To: Water Rights Application File G-17741

Subject: Well interference analysis

PUBLIC INTEREST REVIEW FOR GROUNDWATER APPLICATIONS

SUBJECT: Application G- 17741 Supersedes review of _____
Date of Review(s)

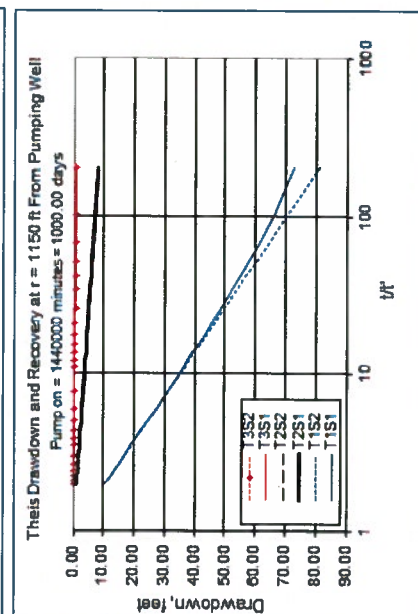
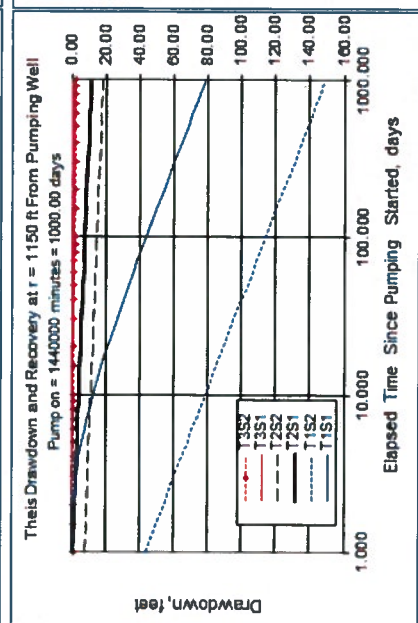
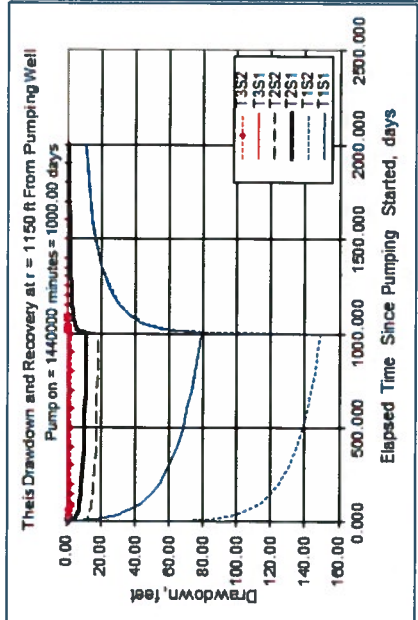
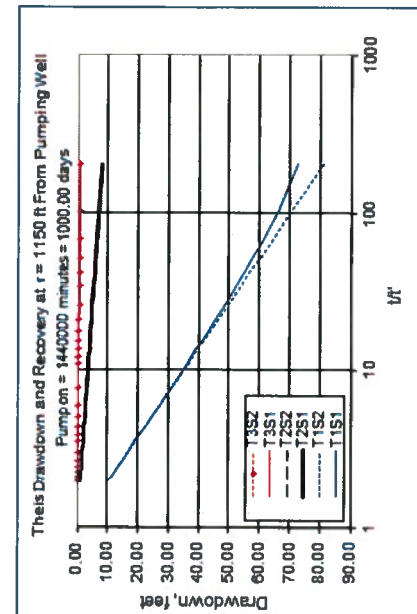
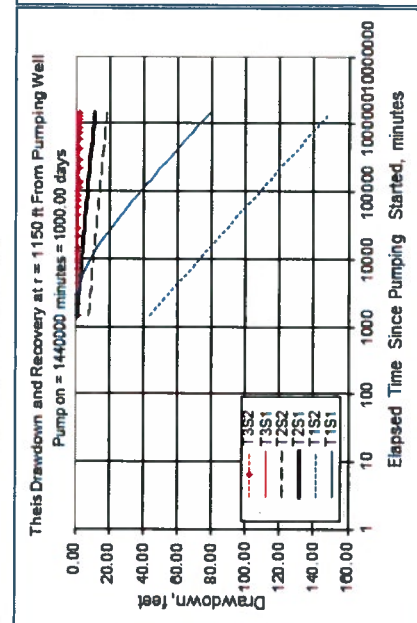
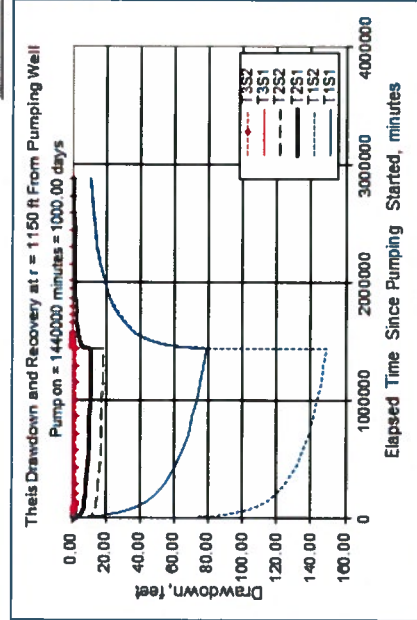
The city's application map puts their proposed well about 1,150 feet from Mr. Sackos' well. An interference analysis was done to assess the potential impacts to BAKE 1136 from pumping at the proposed POA in G-17741. Calculations of expected drawdown were performed using the non-equilibrium solution of Theis (1941) for a pumping period of 1,000 days. The pumping rate (1,000 gpm) was set at the maximum requested rate in G-17741. A range of transmissivities between 1,000 ft²/day to 10,000 ft²/day were used in the analysis. This corresponds to local pump test data and values calculated by Gonthier (1985) for sediments in the Grande Ronde Valley. A range of storativity values were utilized in the analytical solution (0.01-0.0001) to capture the range of reasonable aquifer conditions for the geologic material encountered in area wells. In this part of the valley, well logs indicate the saturated zone in the alluvial aquifer system ranges between 200 and 250 feet thick, and is composed of interbedded gravels, sands, and clays.

The analysis resulted in estimates of between 11 feet and 149 feet of drawdown at BAKE 1136 after 1,000 days of pumping. The high yield reported in BAKE 1136 by the well owner, in addition to pump test calculations from nearby wells, indicates that the probable drawdown is much closer to the low end of this range. The probability of injury to BAKE 1136 (permit G-17346) is therefore remote considering the saturated aquifer thickness and the well depth of BAKE 1136.

D1. Well #: 1 Logid: BAKE 1136

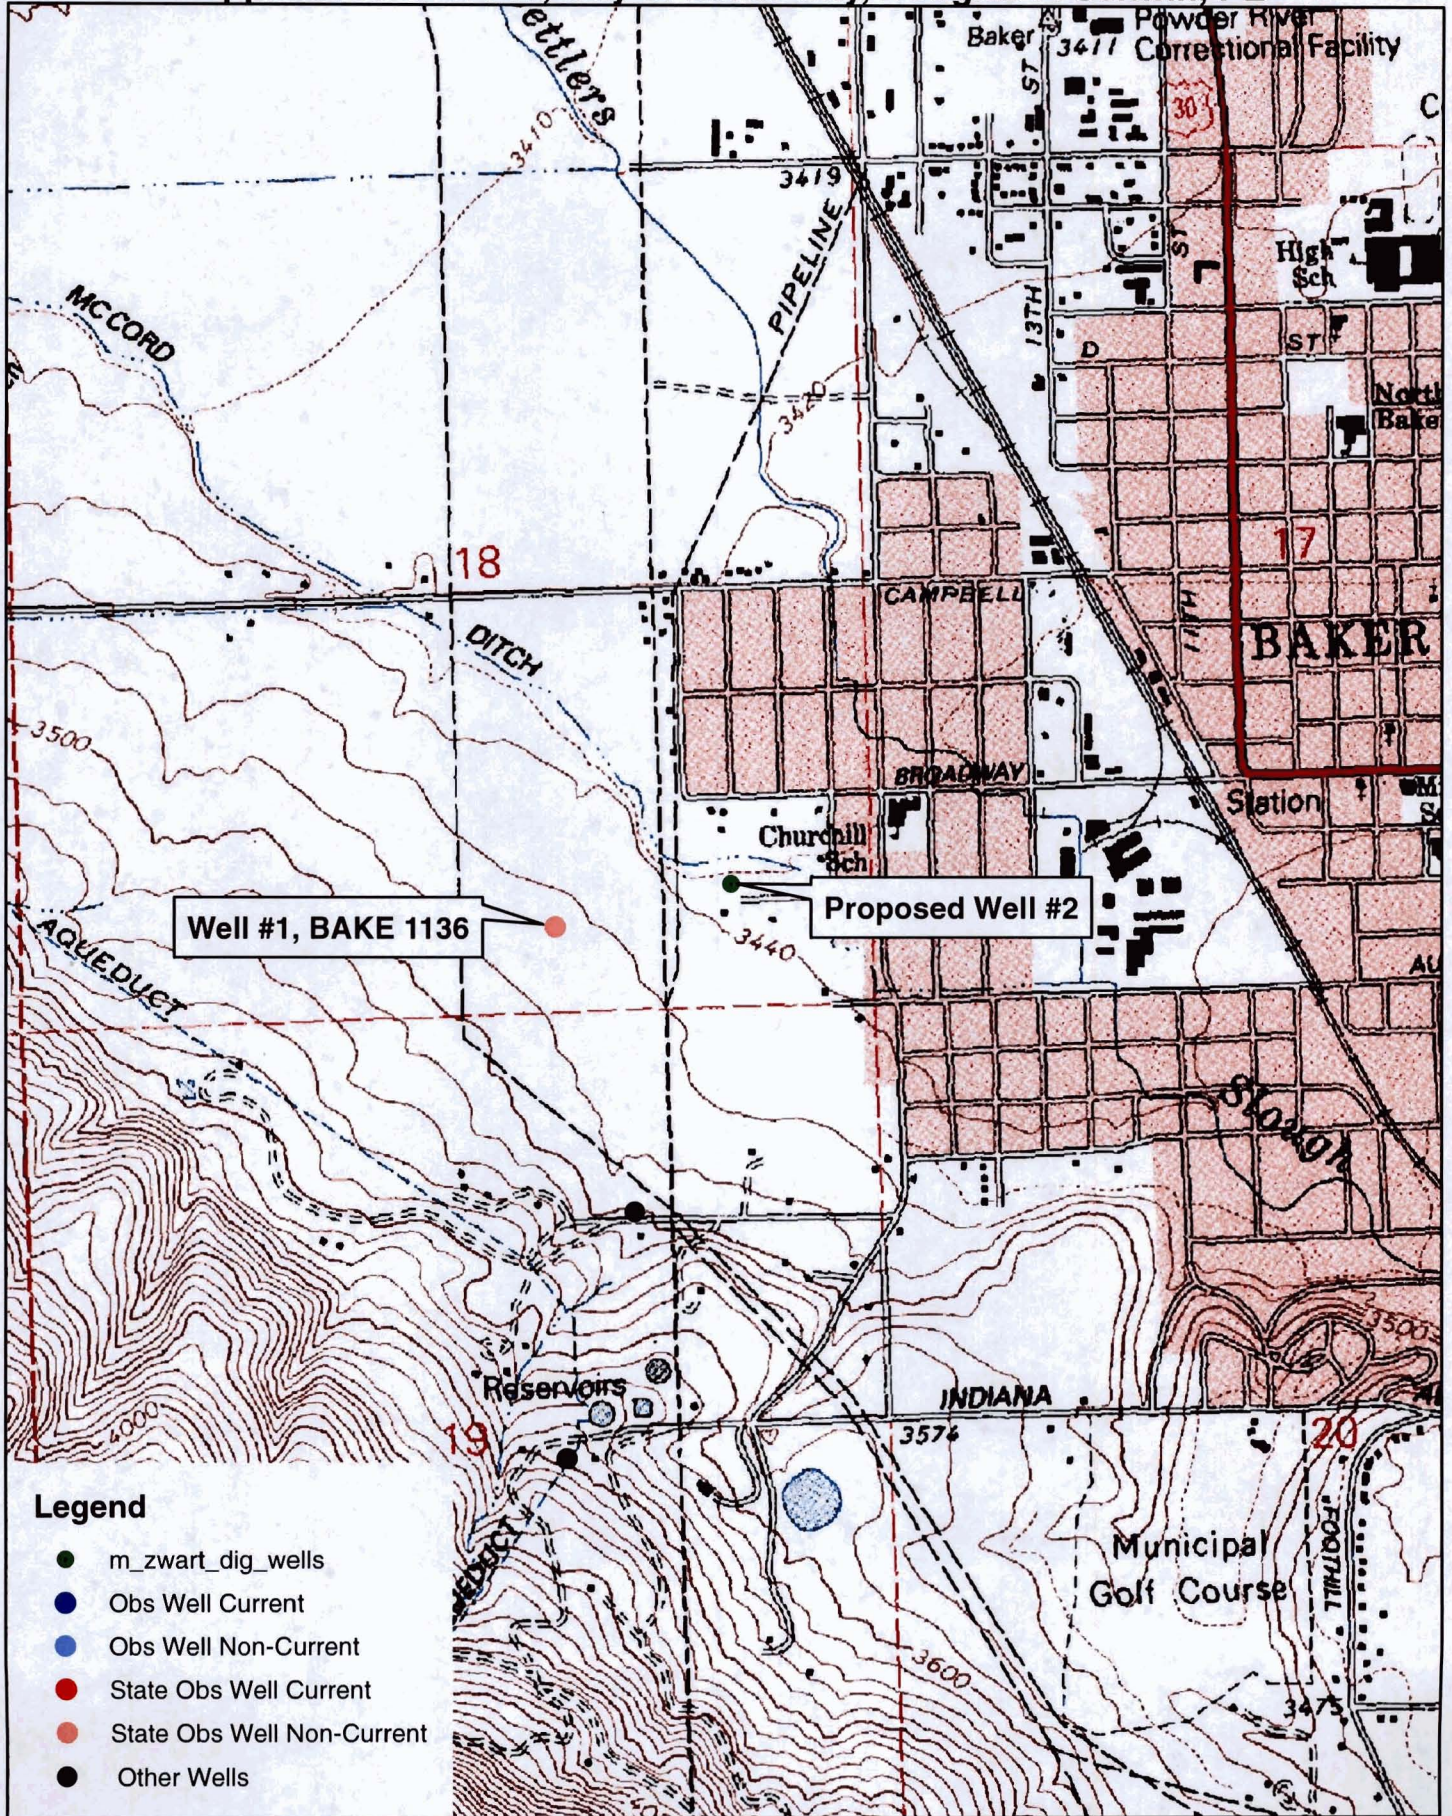
D2. **THE WELL does not appear to meet current well construction standards based upon:**

D3. **THE WELL construction deficiency or other comment is described as follows: There is no well seal reported at BAKE 1136. This well was also proposed in file G-17718 and the Department is requiring repair of it prior to issuing a permit. Since the well log does not report multiple water-bearing zones, the requirement was to only provide a seal to at least 18 feet. The proposal here is for a much deeper seal. This will therefore eliminate any possibility of commingling, should there actually be water-bearing zones in the shallow gravels that were not reported on the original well log.**

D4. Route to the Well Construction and Compliance Section for a review of existing well construction.
